# Technical Bulletin

Bulletin No.: TCH-001-030 Effective Date: 10/28/87 Cancels: PRO-01-30 Dated 3/2/87 Page: 1 of 2

Subject: **Compressors for D.D.A.D. Series 60 Engine**

COMPRESSOR DRIVE HUB PART NUMBER FOR SERIES 60 - **298204**

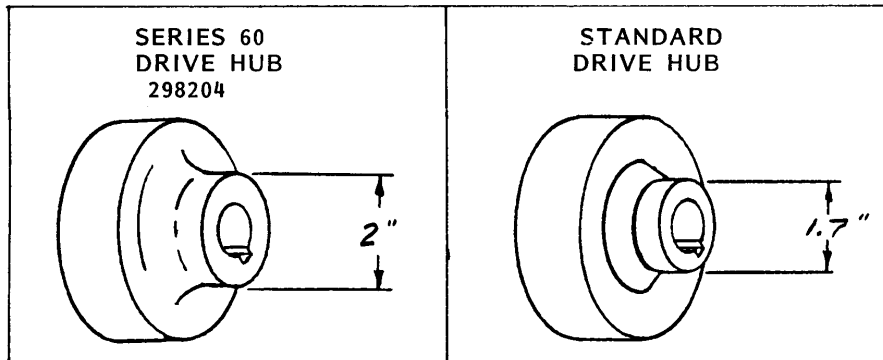
Detroit Diesel has released their new four cycle, Series 60 engine. Because of the increased torsional vibration generated in the accessory gear train of this engine, a stronger compressor and drive hub is required.

Only the specially strengthened and redesigned drive hub and compressors listed in this bulletin can be installed on the Series 60 engine. Installation of part numbers other than those listed may result in drive hub, compressor and/or engine damage.

**Series 60 Drive Hub Identification** - The new Series 60 drive hub 298204 can be distinguished from the standard drive hub by measuring the rear outside diameter.

**Series 60 Drive Hub Installation** - When installing drive hub 298204 on the Series 60 compressor, CRANKSHAFT NUT 298125 MUST BE TORQUED TO 220-254 LB.FT. to properly secure the hub. Depending upon the fit, use either 29 or 30 mm socket. **Caution:** This torque is for Series 60 compressors only and is more than double the maximum specified for the standard D.D.A.D. crankshaft nuts.

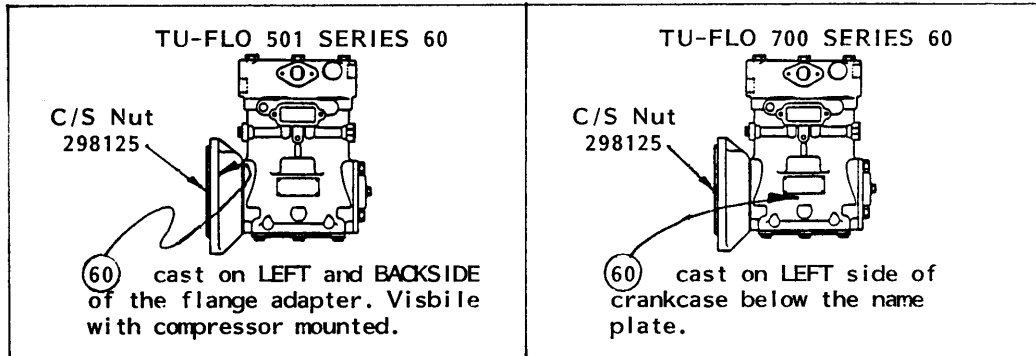
**Series 60 Compressor Identification** - Compressors designed for installation on the Series 60 engine CAN BE POSITIVELY IDENTIFIED WITHOUT THE PART NUMBER by the embossed number sixty inside a circle, (60), located on the crankcase or mounting flange. The symbol is approximately 3/4" in diameter.

In addition, the crankshaft drive end of all Series 60 compressors has an M-20x2.5 metric thread and a flanged nut rather than the standard 3/4"-16 English thread and marsden locking nut. The Series 60 flanged nut part number is 298125.
